MULTNOMAH COUNTY

## ADMINISTRATIVE DECISION

### HILLSIDE DEVELOPMENT PERMIT

File No.: HDP 11-97

**Site Plan**  
 A.1  
 For Permit

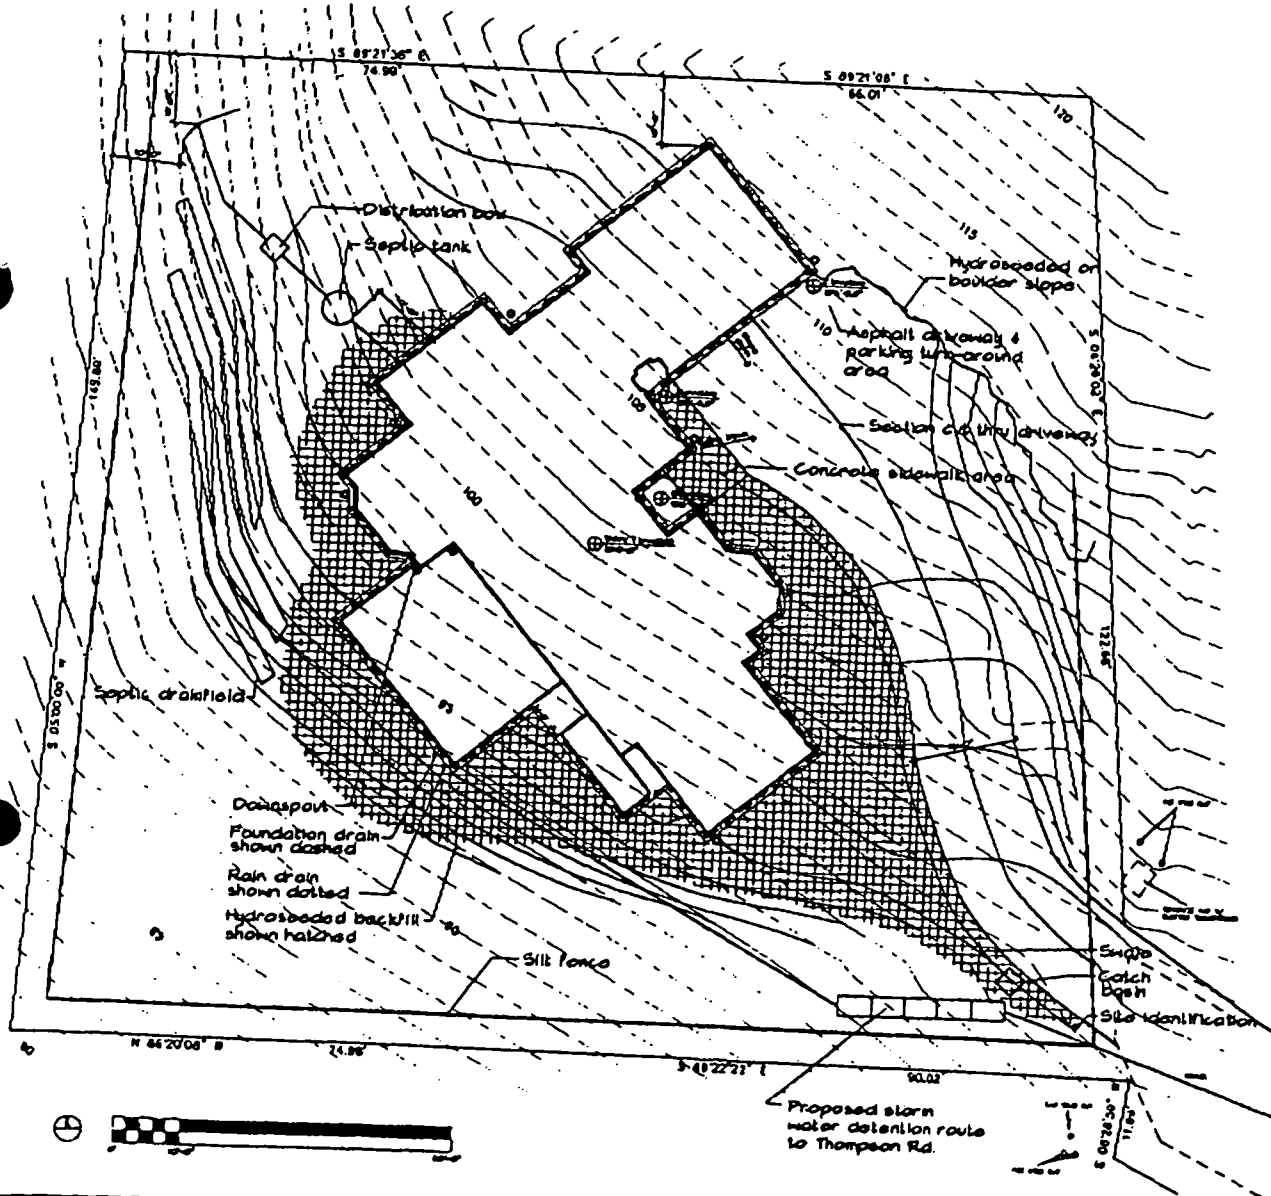
**Finding :** The applicants site plan as revised and illustrated on the HR driveway cross sections map clearly illustrates the location of the proposed drainfield and stormwater detention system.

**Staff:** All replanting will be required to be established (growing and taking to the land) prior to October 15, 1997 or a mitigation plan approved. Staff could find no silt fencing on the submitted plans. Conditions placed on approval will ensure compliance with this criteria.

3. A silt fence (or a silt fence combined with the use of hay bales) is required along all areas down slope from the project site (south of the dwelling site). The silt fence will be required to be in place prior to any earth movement (includes digging footings) and shall remain in place through completion and replanting of trees and vegetation.
